TRANS/WP.29/GRSG/1999/16
27 July 1999

Working Party on General Safety Provisions (GRSG)
(Seventy-seventh session, 25-28 October 1999,
agenda item 3.)

PROPOSAL FOR DRAFT AMENDMENTS TO REGULATION No. 107
(Double-deck passenger vehicles)

Transmitted by the Secretariat

"5.7.4. Access to escape hatches

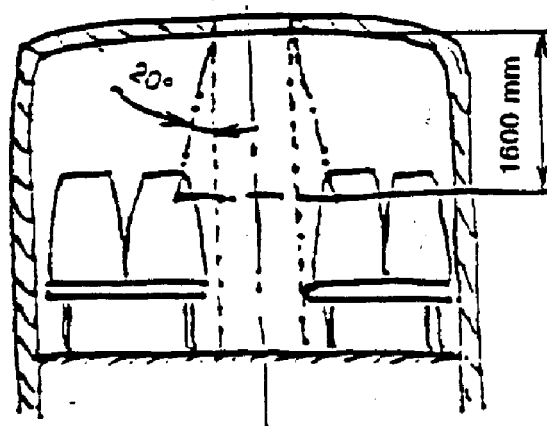
Paragraph 5.7.4., amend to read:

5.7.4.1. At least one escape hatch shall be located such that a four-sided truncated pyramid having a side angle of 20° and a height of 1,600 mm touches part of a seat or equivalent support. The axis of the pyramid shall be vertical and its smaller section shall contact the aperture area of the escape hatch. Supports may be foldable or movable provided they can be locked in their position of use. This position shall be taken for verification.

5.4.7.2. When the structural thickness of the roof is more than 150 mm, the smaller section of the pyramid shall contact the aperture area of the escape hatch at the level of the outside surface of the roof."

SERVICE DOOR DIMENSIONS
(see paragraph 5.6.3.1.)

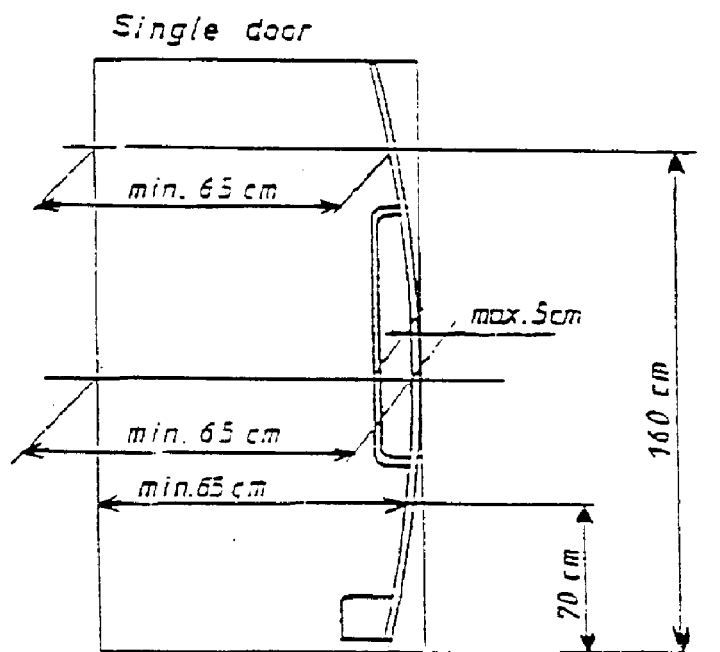
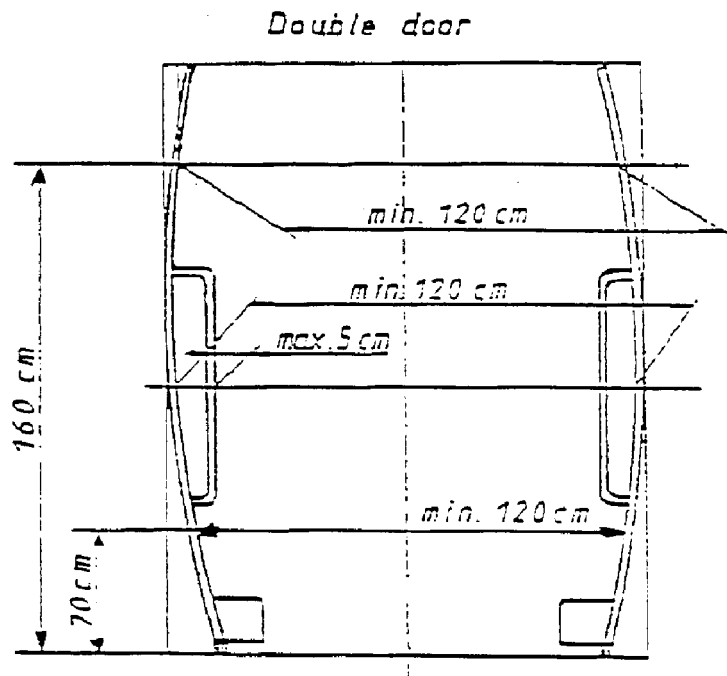
Paragraph 5.6.3.1., amend to read:

" the following minimum dimensions (see also annex 3, figure 16)."

Paragraph 5.6.3.1., the table, service door width, remarks, add at the end the following text:

"... The required width of free access shall be ensured in the height of 70 to 160 cm related to the level of the first step (see annex 3, figure 16)."

Annex 3, insert a new figure 16, to read:

Figure A

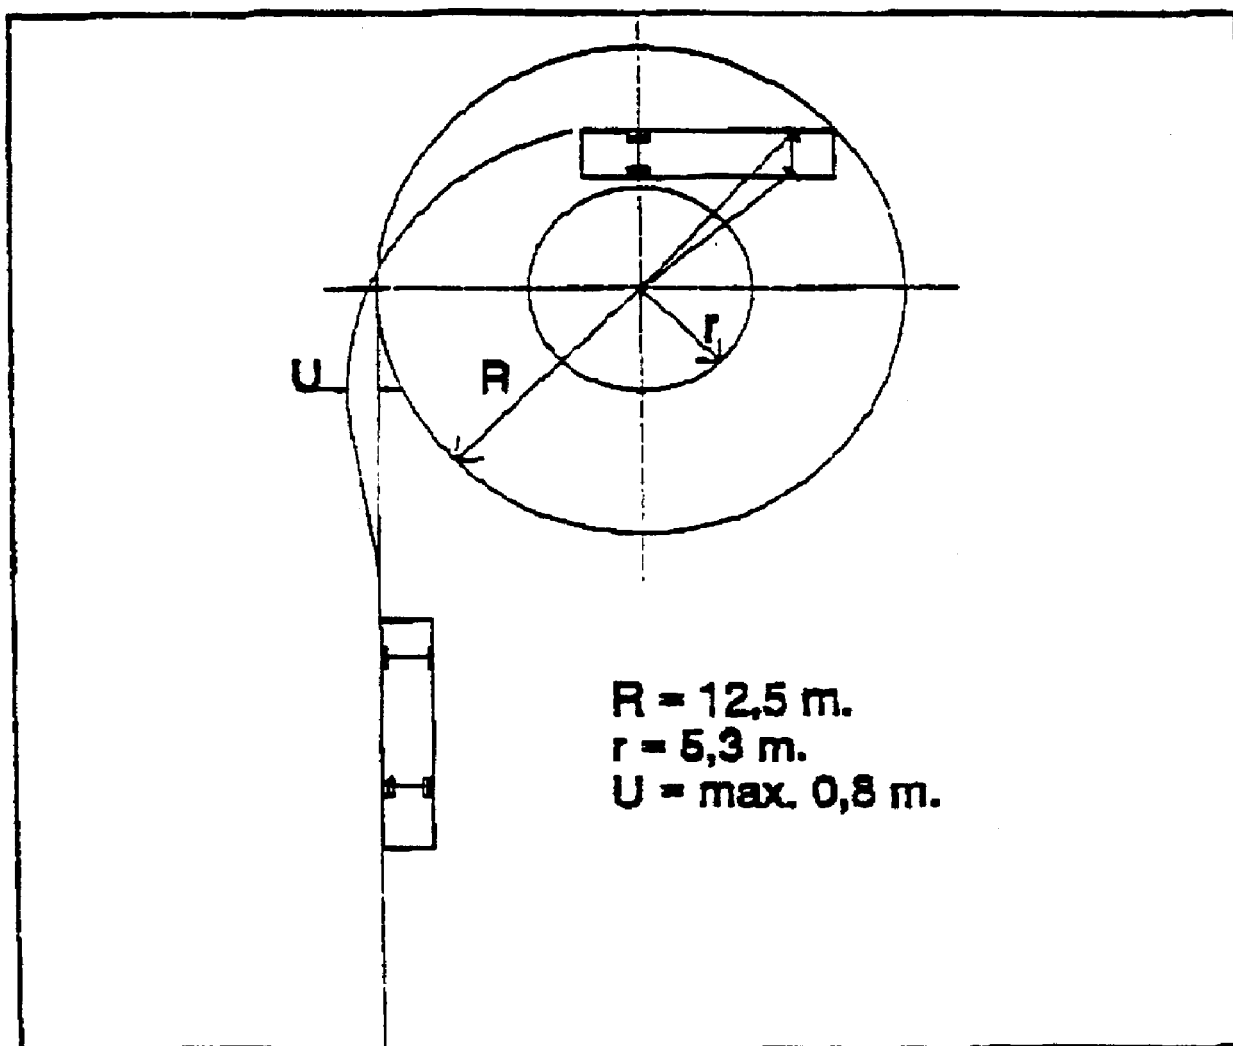
Paragraph 5.10.2., amend to read:

" ... circular track 7.2 m wide (see annex 4 figures A and B)."

Paragraph 5.10.3., amend to read:

"5.10.3. With the vehicle stationary, a vertical plane tangential to the side of the vehicle and facing outwards from the circle shall be established by marking a line on the ground. In the case of an articulated vehicle the two rigid portions shall be aligned with the plane. When the vehicle moves from a straight line approach into the circular area described in paragraphs 5.10.1. and 5.10.2. above, no part of it shall move outside of this vertical plane by more than 0.8 m (see annex 4, figure A) in the case of a rigid vehicle, or by more than 1.2 m (see annex 4, figure B) in the case of an articulated vehicle."

Annex 4, figures A and B, replace by the following figures (figure C being deleted):
